File No.: 44214

██████ ████ ███████ ████ ████ ██████████ ████ ████ ██████████  
██████████ ████ ████ ████ ████

The following is in response to the Section 92 further information request letter dated 21 February 2025 for the subdivision being undertaken by John Raymond McLaughlin at State Highway 6, Addisons/ Virgin Flat.

**Proposed Subdivision of  
Lot 3 DP360520 & easement  
over Lot 2 DP360520**

Figure 1: Broadband Map NZ: Source <https://broadbandmap.nz> Retrieved 10 June 2025.

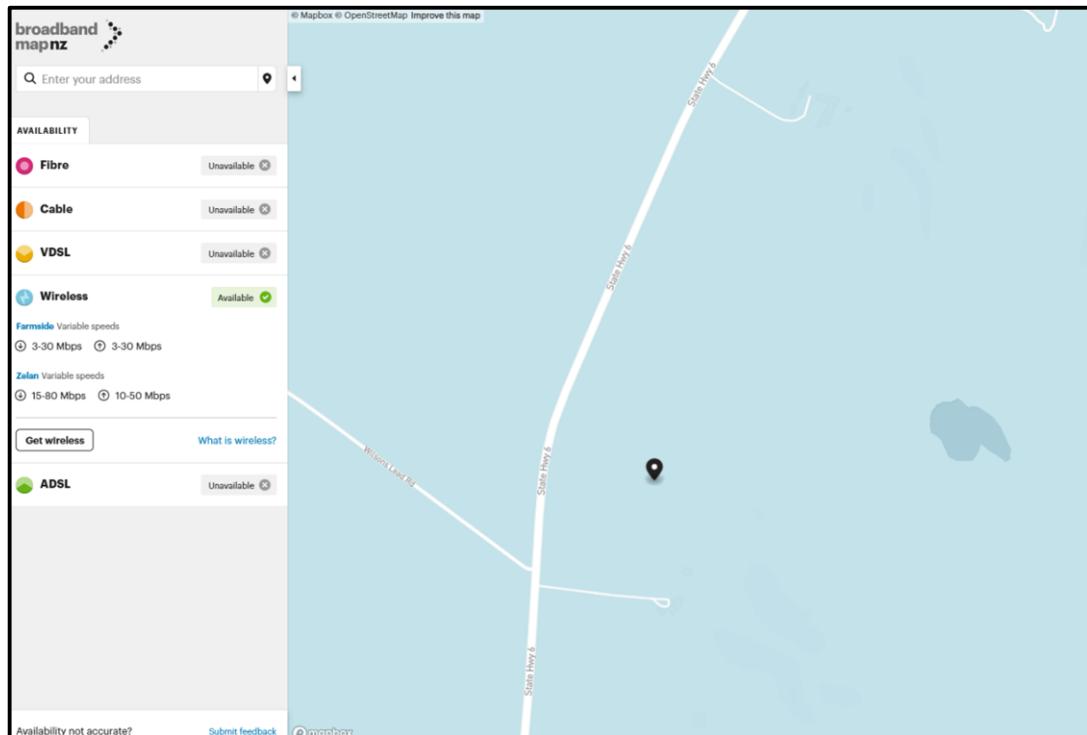
18. *The application contains no details on the supply of telecommunications for the proposed lots. Please provide comment.*

The cost of installing fibre is considered to be prohibitive and an alternative option will need to be provided at time of building development. As per the Broadband NZ website and shown in **Figure 1** below, a wireless telecommunication connection can be provided by both Farmside or Zelan.

**Figures 1** and **Figure 2** below show that alternative telecommunication options for wireless or satellite are available, confirming future residential development can be provided with an
